NOTICE TO ALL CONTRACTORS AND SUB-CONTRACTORS – September 29, 2022
Project Name – USD 305 Salina South High Softball Complex, New Restrooms & Concessions
Project # 22-3260

ADDENDUM NO. 3

SHEET:
L1

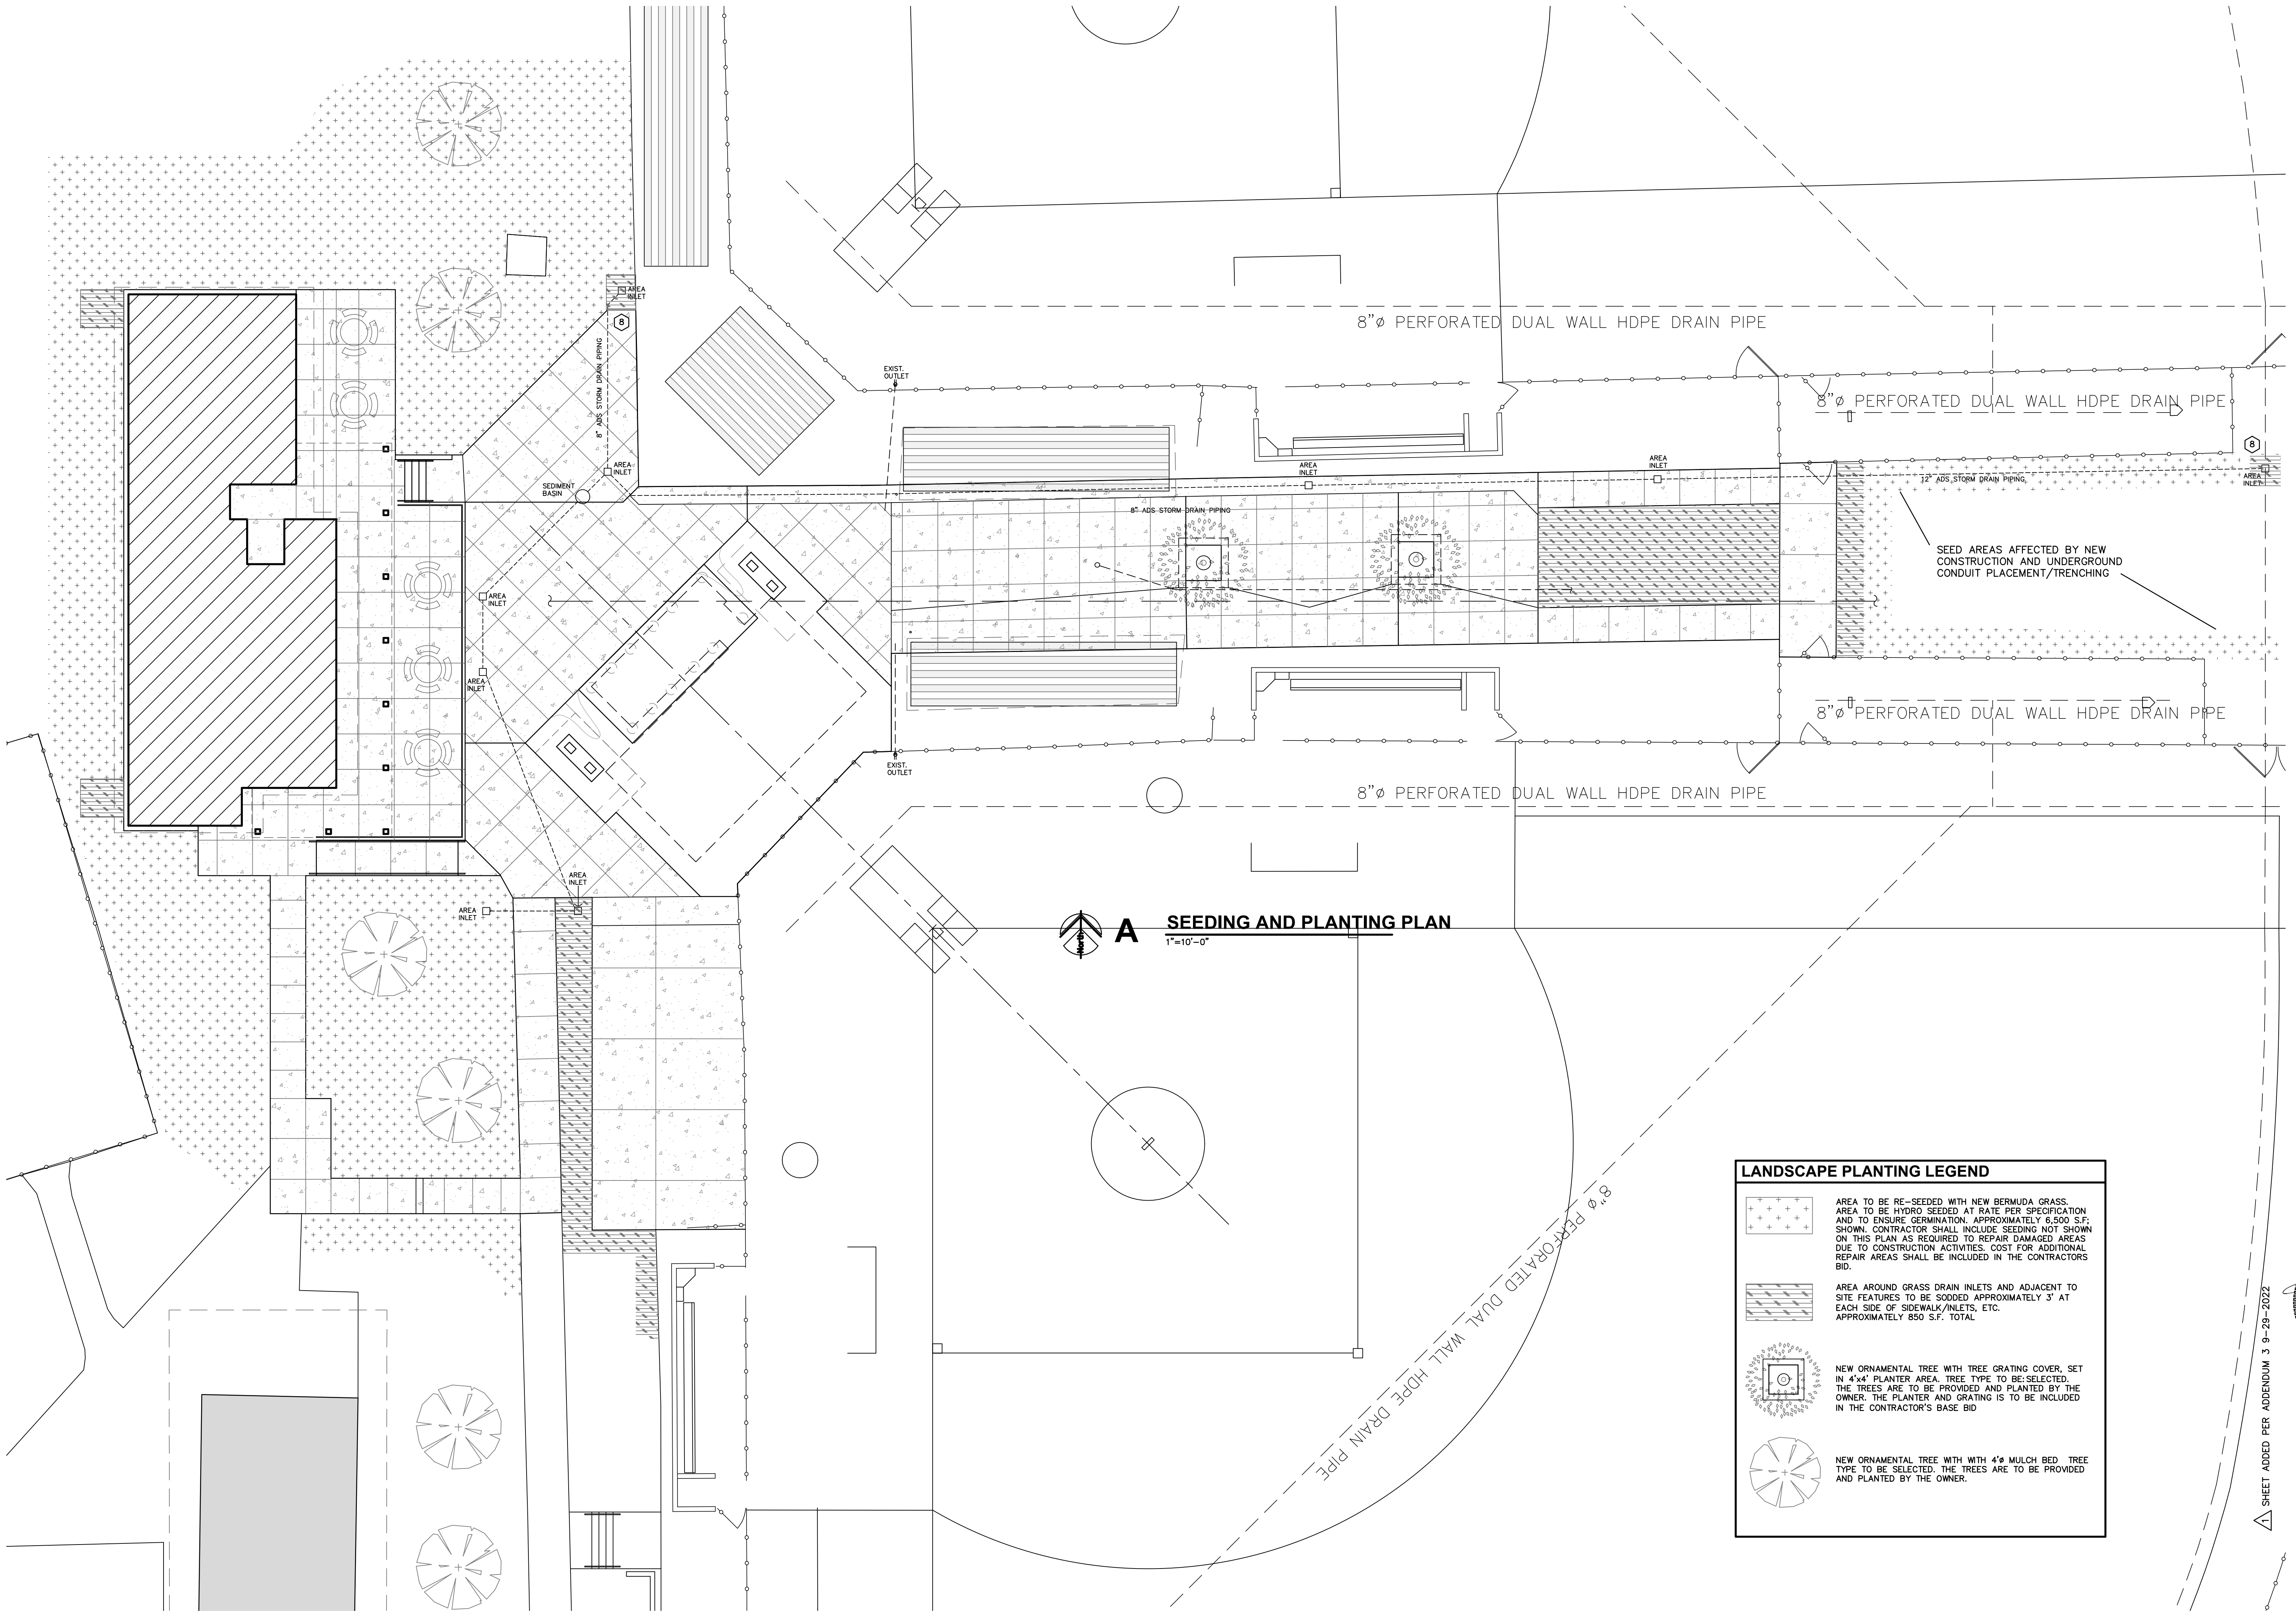
1. Sheet A4.1 – Delete the reference to the Precast Medallion at the exterior brick wall.
2. Sheet L1 - Add the attached L1 sheet to the construction drawings. This plan reflects seed and sod requirements for the project area.

2 CONCESSIONS STAND WATER
 1/4" = 1'-0"

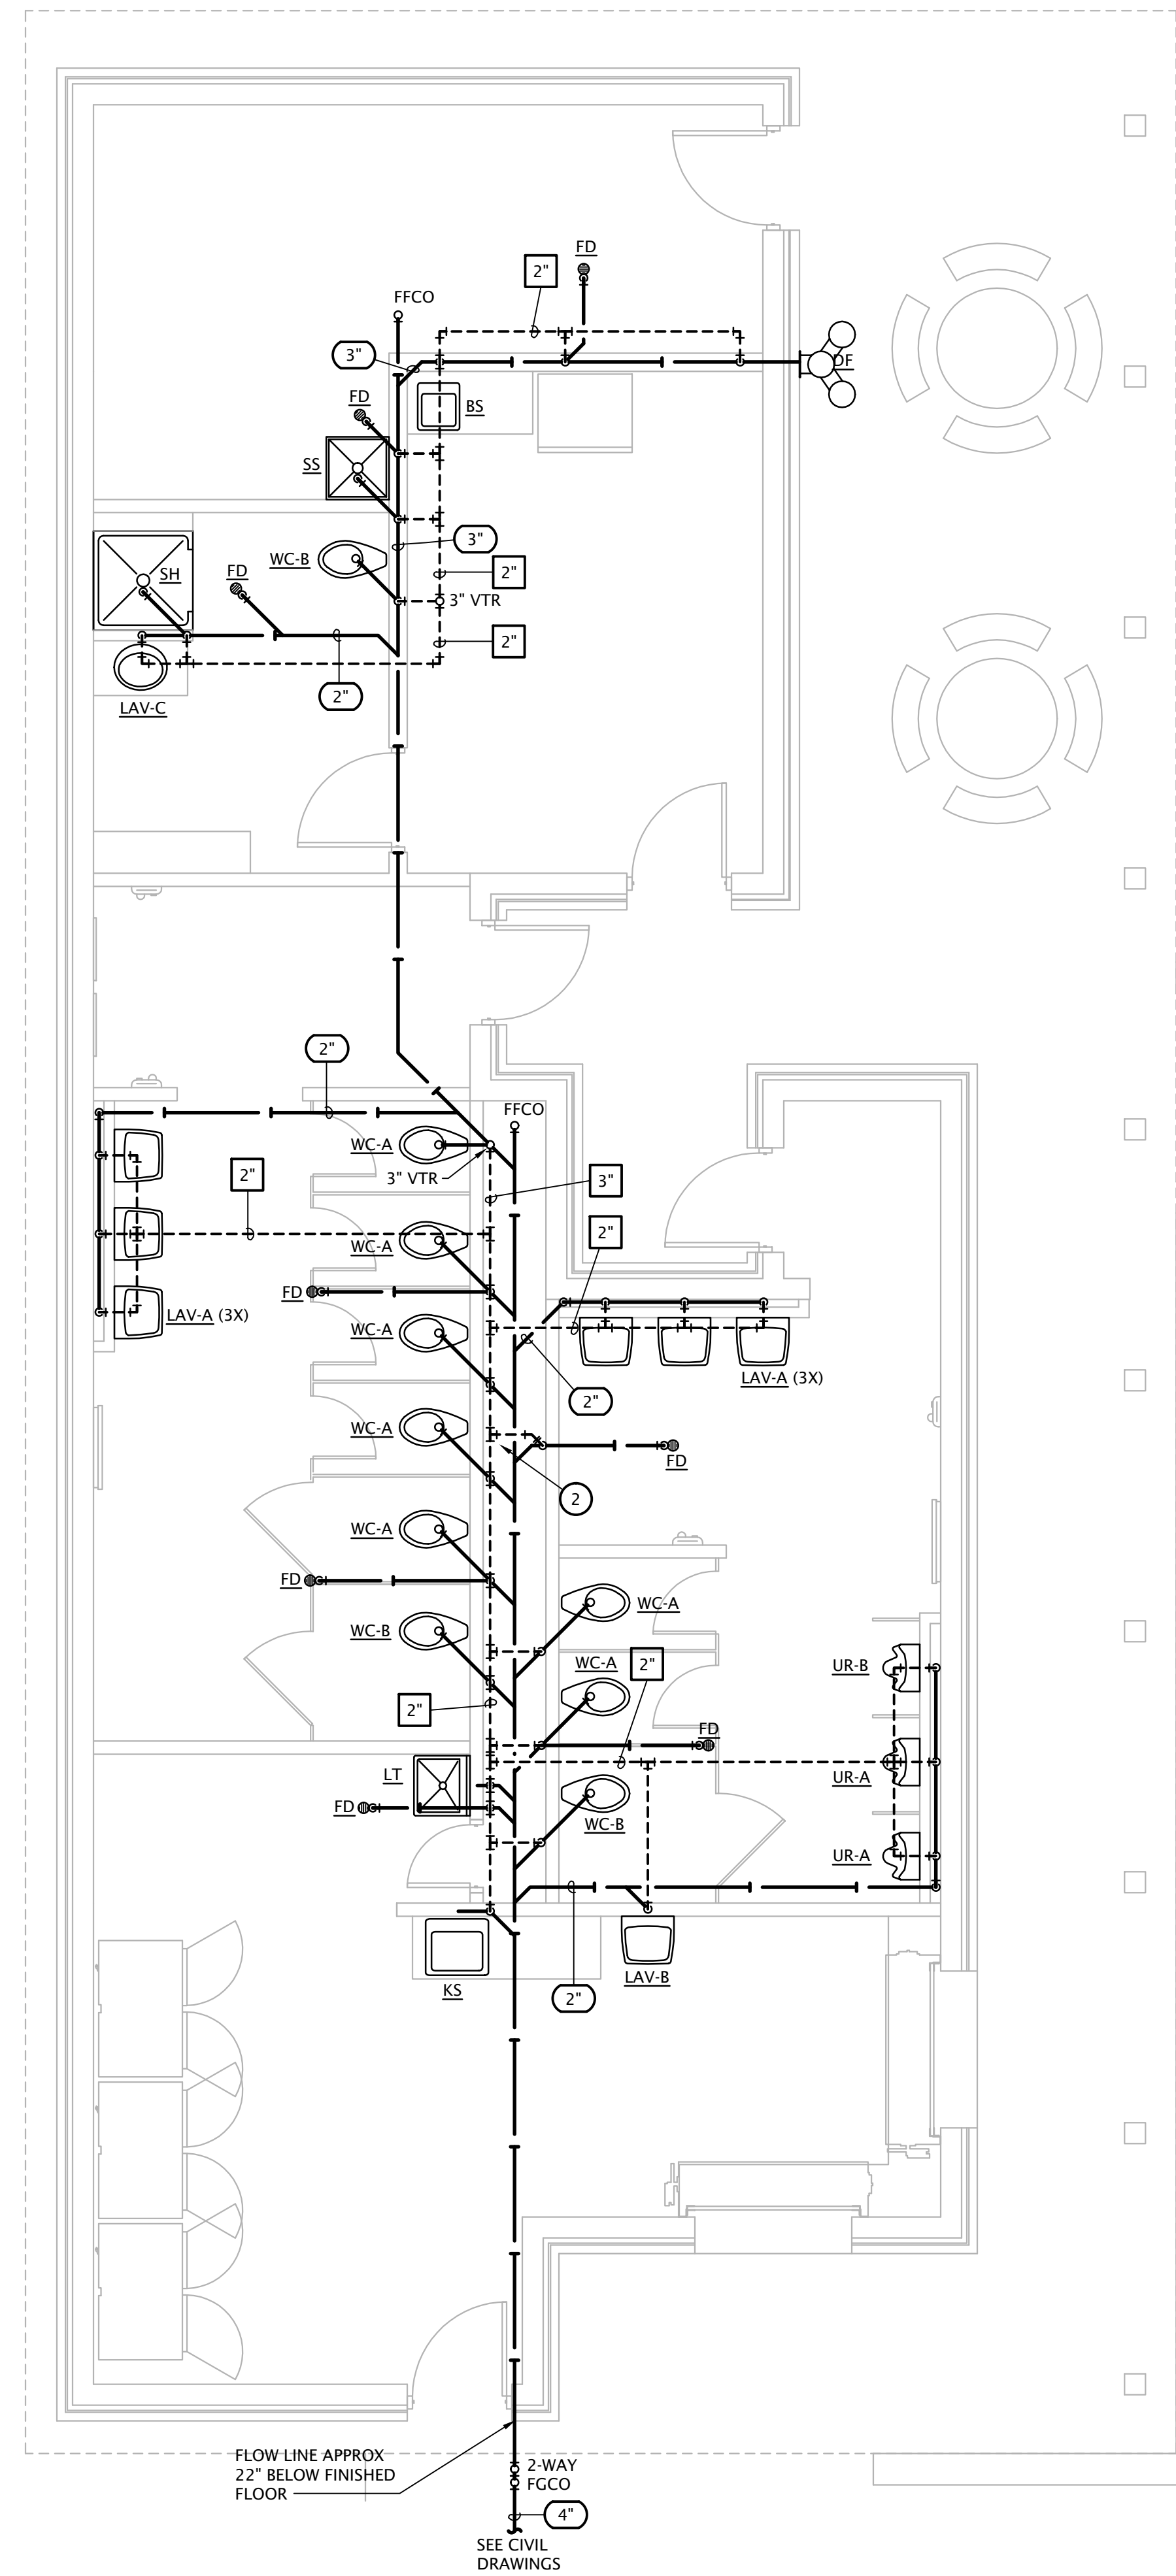
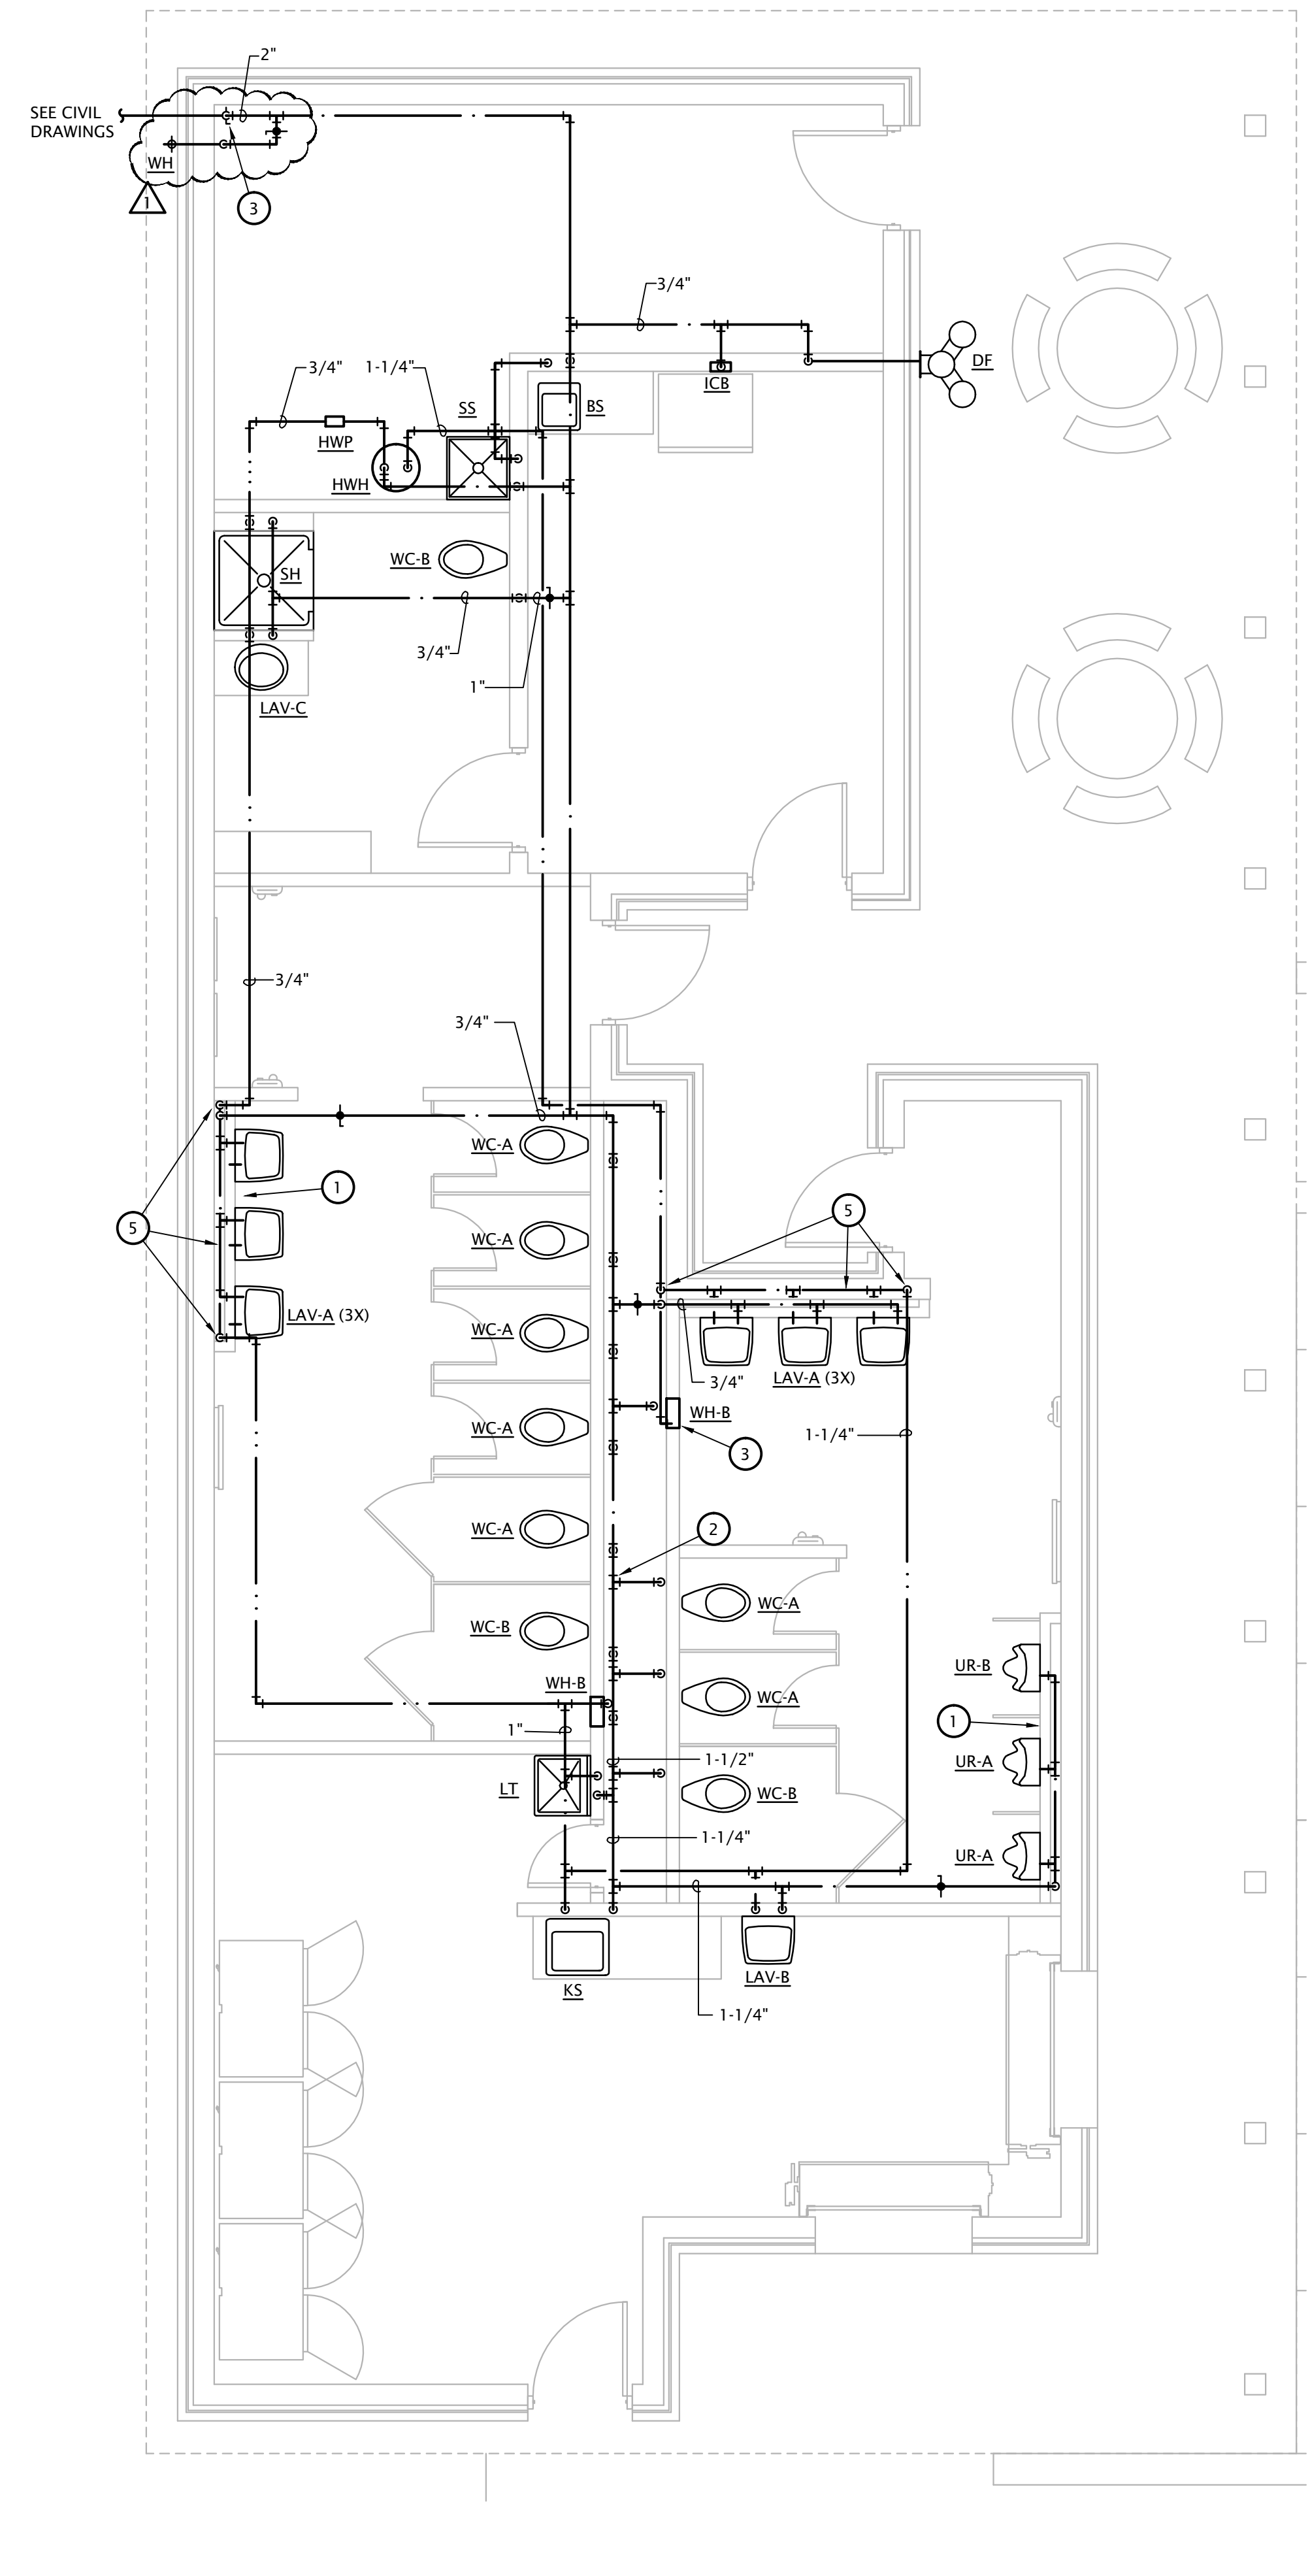
1. Sheet M1.2 – Revised sheet attached. Added wall hydrant and general note for domestic water plan.
2. Sheet M6.1 – Revised sheet attached. Revised Plumbing Fixture Schedule.
